[Docket No. 95-CE-14-AD; Amendment 39-9666; AD 96-12-23]

Airworthiness Directives; Cessna Aircraft Company 150 and A150 Series and Models 152 and A152 Airplanes

ACTION: Final rule.

FIGURE 1  
MID-AMERICA DWG NO. 1001  
(STC SA1371SW)

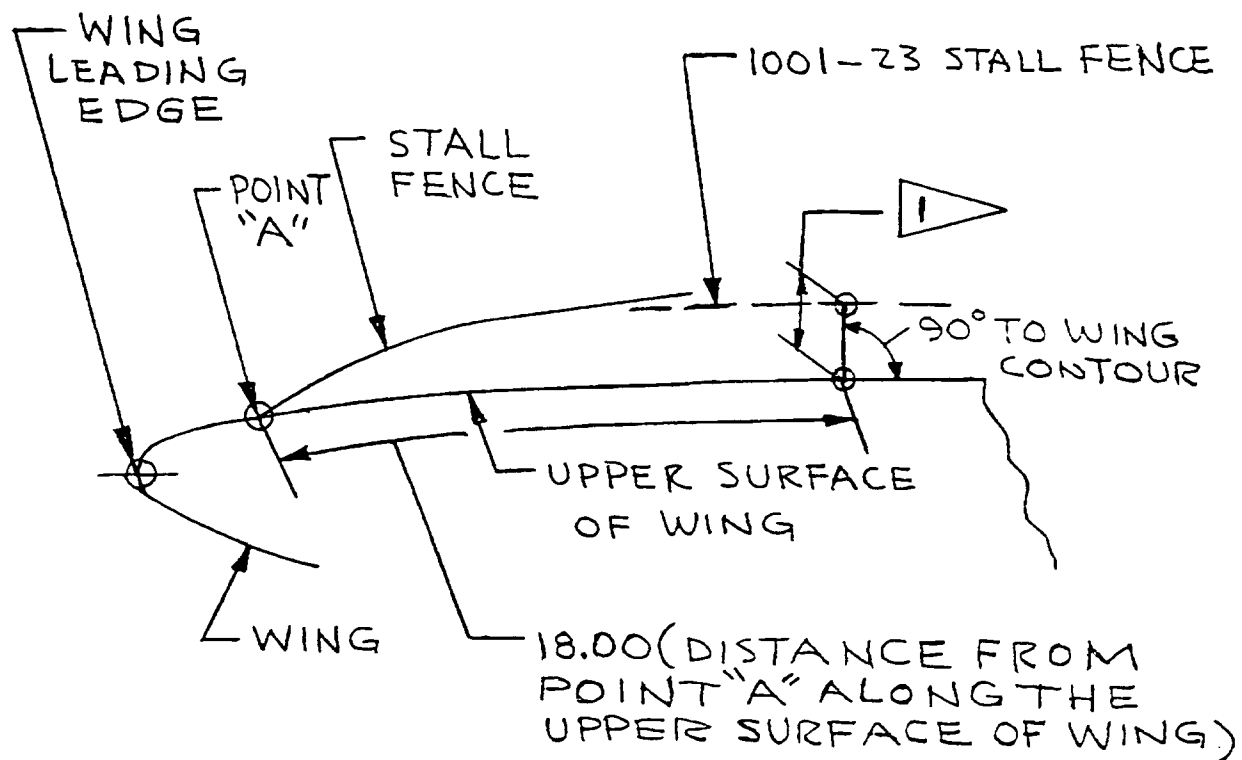
(a) Measure the height of the wing stall fence at its trailing edge to ensure that the height does not exceed 1.28 inches. (See Figure 1 of this AD).

1 IF STALL FENCE IS  $1.16 \pm .12$  HIGH THAT IS CORRECT HEIGHT FOR CESSNA 150/152. IF GREATER THAN 1.28 HIGH REMOVE STALL FENCES AND INSTALL THE CORRECT ONE.

(b) If the wing stall fence height exceeds 1.28 inches, prior to further flight, install a smaller fence in accordance with instructions obtained from the Wichita Aircraft Certification Office (ACO), FAA, 1801 Airport Road, Mid-Continent Airport, Wichita, Kansas 67209.
